REGIONAL REVIEW FINDING

DATE: May 24, 2021 **ARC REVIEW CODE:** R2105071

RE: Development of Regional Impact (DRI) Review

Name of Proposal: Union City Commerce Center DRI #3266

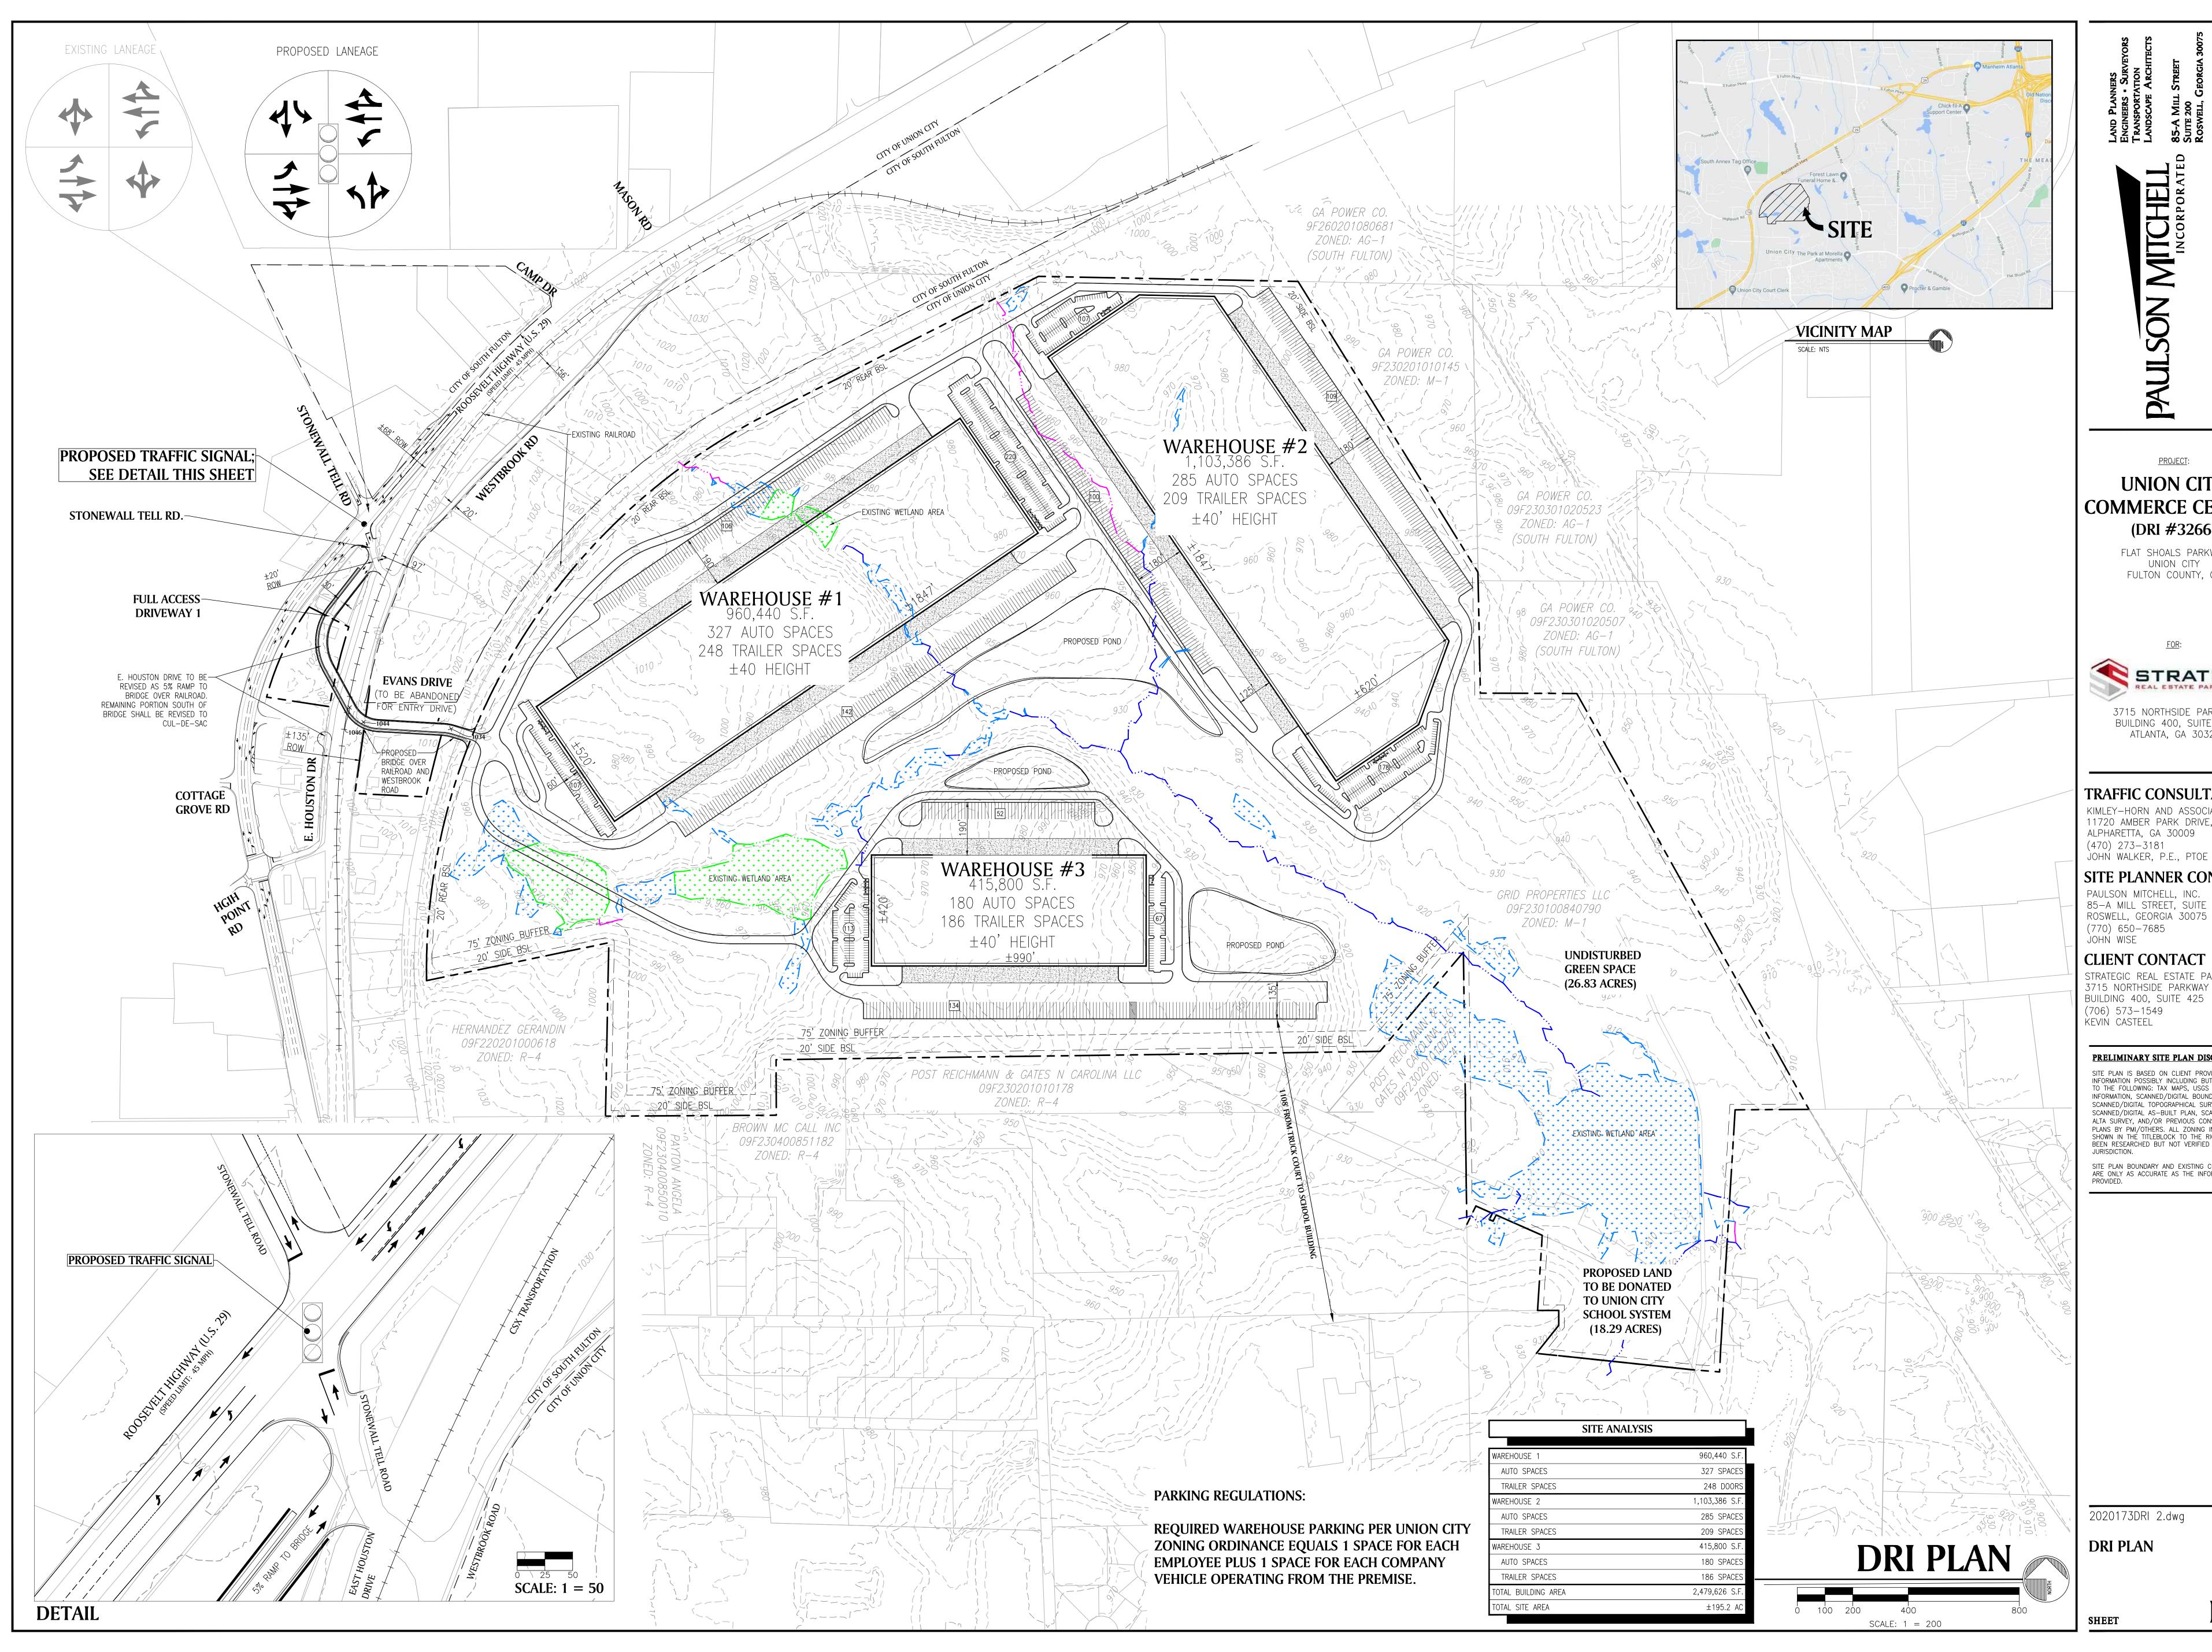
The USGS coverage for the project area shows an unnamed blue line tributary of Morning Creek crossing the property, along with a blue-line tributary to the unnamed stream. Both streams are shown on the submitted site plan. Warehouses 1 and 2, associated parking areas and a proposed pond are shown crossing both streams. The City of Union City has adopted a stream buffer protection ordinance that requires a 50-foot undisturbed buffer and an additional 25-foot impervious surface setback on most streams in the City. In addition, Georgia's 25-foot State Erosion and Sedimentation Act buffer applies to waters of the state. These buffers should be shown on the project site plans. Development within these buffer will require variances. Any unmapped streams may also be subject to the City buffers and unmapped waters of the state may be subject to the 25-foot State Erosion and Sedimentation Act buffer.

Section 1.4 references the outlining of Union City's sidewalk project in Section 8.0; however, this section is not available, or it is mis-referenced.

Provide alignment clarification regarding the proposed pedestrian facilities along the proposed driveway. Section 1.2 indicates the driveway will be bridged over two sets of railroad tracks. Since the proposed driveway will not be at grade, due to the railroad, has the team examined the potential needs of ADA compliance?
